RE: 1919 O'Farrell Street

I reviewed a previous design for this site one year ago. In reviewing the current drawings and the site context, I have the following comments.

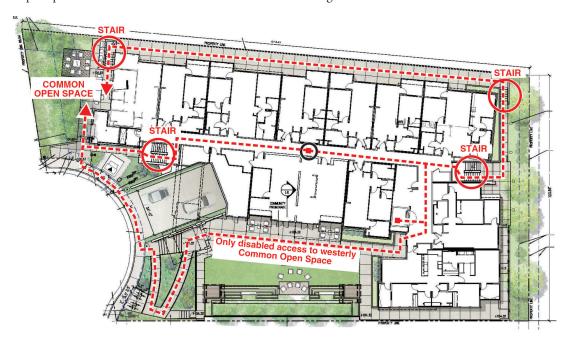
- 1. The distance between the vehicle drop off area and the Lobby is quite long.
- 2. The Lobby seems pretty minimal in size for a multifamily residential project of this size and quality.

The open stair well seems unusual for a project of this quality.
 Recommendation: Consider adding glazing to the exterior wall of the stair well.

Recommendation: Given the obvious issues, it is likely that a full range of alternative options has been explored by the design team. Staff should discuss this with the applicant to see if other approaches might mitigate the walking distance to and size of the Lobby. Another mitigation measure could be to add a weather covering over the long walkway to the Lobby. A couple of examples are shown below.

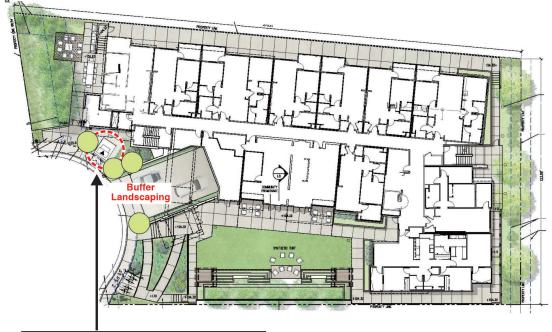
4. The retention of the cluster of redwood trees at the westerly edge of the property is very good both in terms of the streetscape terminus of the cul-de-sac and the provision of a high quality open space amenity for the residents and their guests. Access to this common open space amenity, however, is not very good, and would be highly inconvenient for any disabled residents or guests. Access routes are long with many stairs along the way - not ideal for the open space's intended use as an outdoor barbecue and dining area.

Recommendation: Explore more direct access route and floor-height-to-open space transitions.

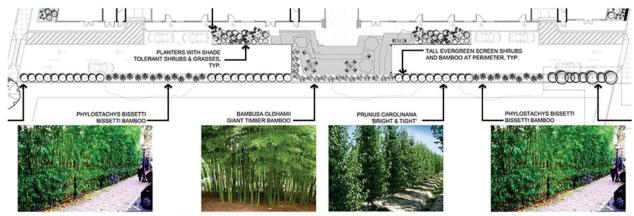
5. The cul-de-sac terminus bulb forces the resident and guest entry, garage entry ramp, trash pick up and utility connections into a limited frontage area. The operational features are not the best neighbors for the pedestrian entry experience.

Unclear if transformer is visually buffered
Consider enclosure and landscaping

Recommendation: Enclose the ground-mounted transformer. One example can be found at the San Mateo Metropolitan Apartments on the Fifth Avenue frontage - see photo below.

Additional landscaping would be desirable to soften the appearance of this small area and to visually separate the pedestrian entry from the garage ramps and transformer - see plan on page 6 and sketch illustration below.
